Access Compliance Report Public Rights-of-Way (Curb Ramps)

Main Street: NEWPORT_AVE Cross Street: HYDR_PARK_DR Location: SE

ADA ID: RPRK211012174452 Ramp Type: Type 4 - Parallel Initial Pass/Fail: Fail Overall Compliance: No Severity Score: 2

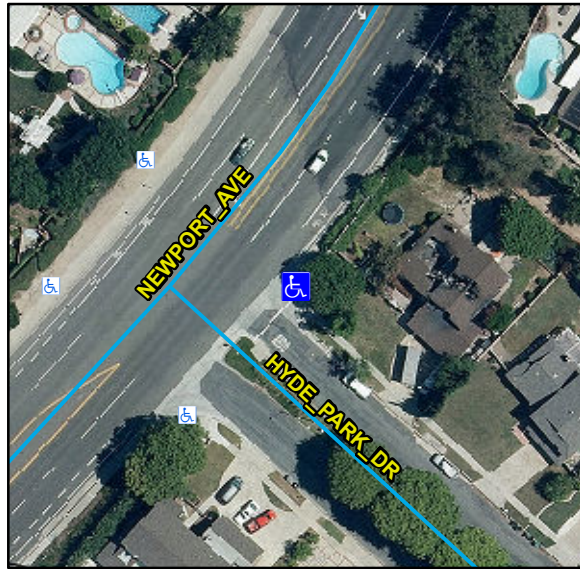
Compliance	Description	Data	Compliance	Description	Data
N/A	Ramp Length LT (in)	98	N/A	Ramp Length RT (in)	107
Yes	Ramp Width LT (in)	74	Yes	Ramp Width RT (in)	88
Yes	Ramp Run Slope LT (%)	5.7	Yes	Ramp Run Slope RT (%)	4.4
No	Ramp Cross Slope LT (%)	2.3	Yes	Ramp Cross Slope RT (%)	1
N/A	Landing Present	N/A	N/A	DWS Provided	N/A
N/A	Landing Length (in)	N/A	N/A	DWS Contrast	N/A
N/A	Landing Width (in)	N/A	N/A	DWS Length (in)	N/A
N/A	Landing Run Slope (%)	N/A	N/A	DWS Full Width	N/A
N/A	Landing Cross Slope (%)	N/A		DWS Offset Type	N/A
N/A	Landing Movement Obstructed?	N/A	N/A	DWS Offset Left (in)	N/A
	Landing Movement Type	N/A	N/A	DWS Offset Right (in)	N/A
N/A	Landing Shared	N/A			
N/A	Clear Space	Yes			
N/A	Clear Space To Crosswalk (in)	N/A			
N/A	Marked Crosswalk 1	No	N/A	Marked Crosswalk 2	No
	Crossing 1 Direction	NW		Crossing 2 Direction	SW
	Marked Crosswalk 1 Width (in)	N/A		Marked Crosswalk 2 Width (in)	N/A

Remove & Replace Curb Ramp With Two New Directional Ramps or Equivalent.

R304.5.3, STD 1115
